Urgent Field Safety Notice Product Correction

Product Name	List Number	Serial Number	UDI
Mixer	09D59-01 09D59-02 09D59-03	All	Not applicable

This Product Correction letter is to inform you of an issue with the ARCHITECT c Systems Mixer (LN 09D59-01, 09D59-02, and 09D59-03). There is the potential for the mixer blade, attached to the mixer with a screw and nut, to separate from the mixer. The missing mixer blade will result in inadequate mixing of the reaction mixtures leading to potential incorrect results (failed assay calibration, Quality Control (QC) out of range, and/or incorrect patient results). The impact on the test result may vary depending on the assay being performed and the viscosity of the patient sample.

Appendix A: Mixer Inspection Procedure

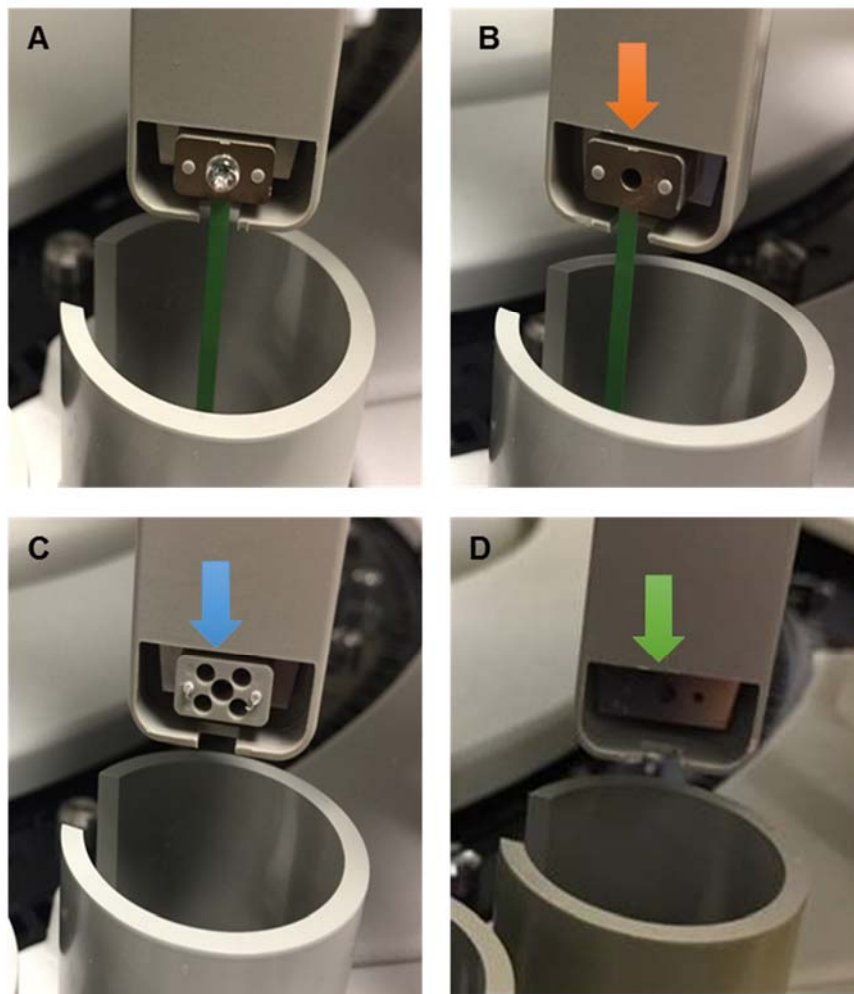
To inspect each mixer, open the rear cover of the processing module and inspect the mixer. Verify the mixer blade and screw is present.

If a mixer blade and/or screw are missing

The following pictures show a A) normal mixer B) mixer missing the mixer screw (orange arrow pointing to missing screw), C) missing mixer blade with spacer shim present (blue arrow pointing to missing mixer blade), and D) missing mixer and spacer (green arrow pointing to missing mixer blade and spacer).

1. Replace broken mixer. Refer to *Replace the Mixer (c4000, c8000, c16000)*¹.
2. Replace the cuvette dry tip. Refer to *Replace the cuvette dry tip (c4000, c8000, c16000)*¹.
3. Follow the instructions in **Appendix C** to inspect all cuvettes to ensure that the screw or nut did not fall into an individual cuvette.

Appendix D: Additional Precautions for Weekly procedure *6021 Clean Mixers*¹:

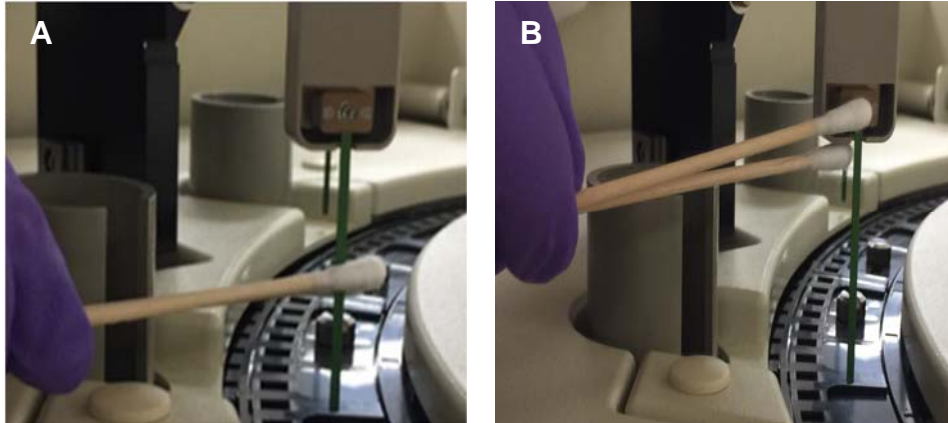
When performing weekly maintenance procedure *6021 Clean Mixers*¹, it is recommended to not let the mixer screw and 70% isopropyl alcohol come in direct contact.

The below pictures show A) the proper cleaning of the mixer and B) improper contact of the 70% isopropyl alcohol with the mixer screw.
